# DRAFT AIA Document G701™ - 2001

## Change Order

| <b>PROJECT (Name and address):</b><br>Radcliff Elementary School Renovation<br>- Phase 3<br>1145 S. Dixie Boulevard<br>Radcliff, Kentucky 40160 | <b>CHANGE ORDER NUMBER:</b> 006<br><b>DATE:</b> June 16, 2011                                                                  | <b>OWNER:</b> <input checked="" type="checkbox"/><br><b>ARCHITECT:</b> <input checked="" type="checkbox"/><br><b>CONTRACTOR:</b> <input checked="" type="checkbox"/><br><b>FIELD:</b> <input checked="" type="checkbox"/><br><b>KENTUCKY DEPARTMENT OF EDUCATION:</b> <input type="checkbox"/> |

PROPOSAL REQUEST NUMBER: 004

# E4.1A

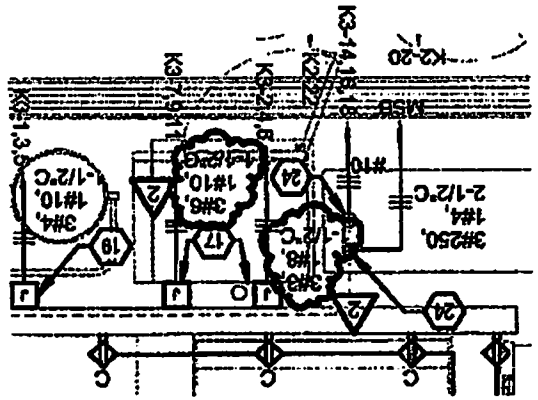
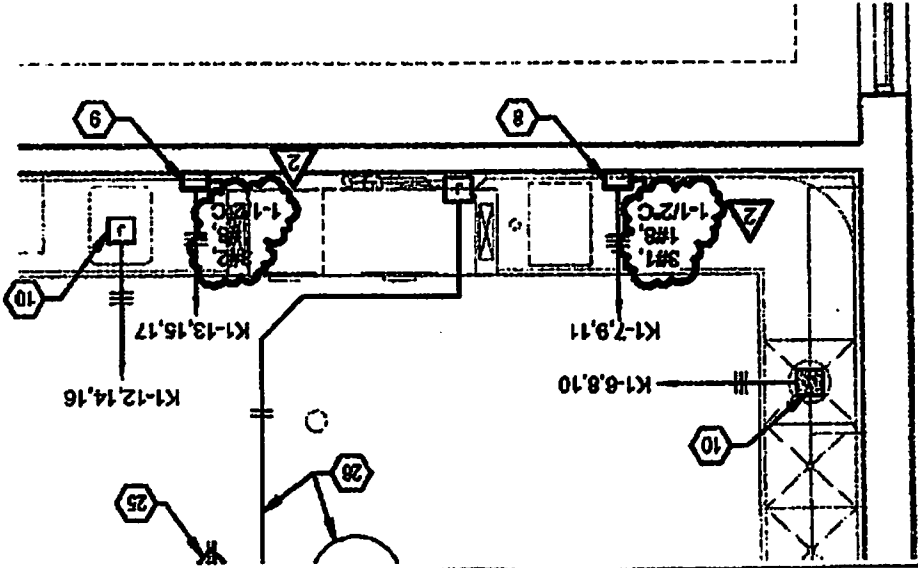
a) Booster Heater (Item #10) - Revise breaker from 125/3 to 100/3. Revise wire and conduit size from 3#1/0, 1#6, 2"C to 3#1, 1#8, 1-1/2"C. Revise disconnect switch from 200A to 100A.

b) Combi-Oven (Item #35) - Revise breaker from 70/3 to 50/3. Revise wire and conduit size from 3#4, 1#8, 1-1/2"C to 3#6, 1#10, 1"C.

c) Combi-Oven (Item #35A) - Revise breaker from 125/3 to 80/3. Revise wire and conduit size from 3#1/0, 1#6, 2"C to 3#3, 1#8, 1-1/2"C.

d) Dishwasher (Item #11) - Revise breaker from 70/3 to 90/3. Revise wire size from 3#4, 1#8, 1-1/2"C to 3#2, 1#8, 1-1/2"C.

Provide credit amounts for revisions to Booster Heater (Item #10), Combi-Oven (Item #35), and Combi-Oven (Item #35A). Provide amount of additional cost for revision to Dishwasher (Item #11). Refer to attached drawing and revised electrical schedules.

- PROVIDE AND INSTALL A 240 VOLT, 100 AMP, 3-WIRE, NON-FUSED DISCONNECT SWITCH IN A NEMA 4X ENCLOSURE FOR CONNECTION TO BOOSTER HEATER. INSTALL BELOW COUNTER, ADJACENT TO HEATER. INSTALL AS REQUIRED TO PROVIDE CLEAR ACCESS IN FRONT OF DISCONNECT.
